USB Type-C ENGINEERING CHANGE NOTICE

Title: CC Voltage Thresholds

Applied to: USB Type-C Specification Release 2.3, Oct 2023

Figure 4-X Pull-Up/Pull-Down Voltage Detection Model

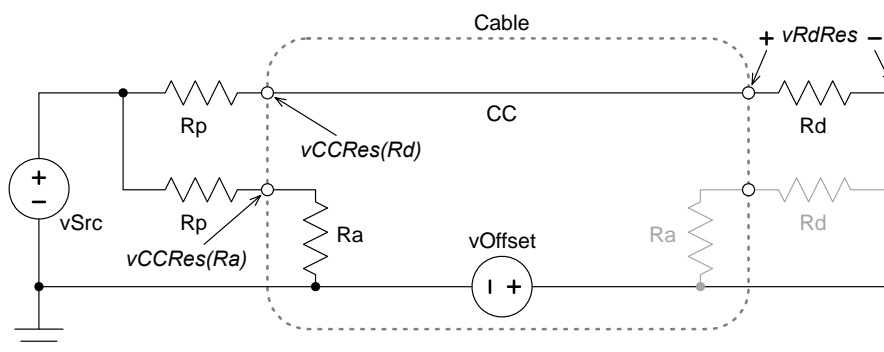
This section provides voltage calculations to be used by a Source to detect an attach and a Sink to detect the **USB Type-C Current** advertisement (Default USB, 1.5 A, or 3.0 A) with some numeric examples. This allows calculations for thresholds of specific implementations to be based on the parameter variances of the implementation.

For calculating threshold settings to detect an Attach by a Source and the Source **USB Type-C Current** advertisement by a Sink, the equations in this section are used. The cable CC wire resistance is considered negligible compared to the Source R_p and Sink R_d and is not included. Each equation calculates the CC pin voltage as seen from the Sink or the Source. Figure 4-X and Figure 4-Y illustrate the two models used to determine these equations, the first based on a pull-up resistor in the Source and the second replacing this with a current source.

$$v_{RdRes(min)} = (v_{Src(min)} - v_{Offset(max)}) \frac{R_d(min)}{R_d(min) + R_p(max)}$$

$$v_{RdRes(max)} = v_{Src(max)} \frac{R_d(max)}{R_d(max) + R_p(min)}$$

$$vCCRes = (vSrc - vOffset) \frac{R_{d|a}}{R_{d|a} + R_p} + vOffset$$

$$vCCRes(min) = vSrc(min) \frac{R_d(min)}{R_d(min) + R_p(max)}$$

$$vCCRes(max) = (vSrc(max) - vOffset(max)) \frac{R_{d|a}(max)}{R_{d|a}(max) + R_p(min)} + vOffset(max)$$
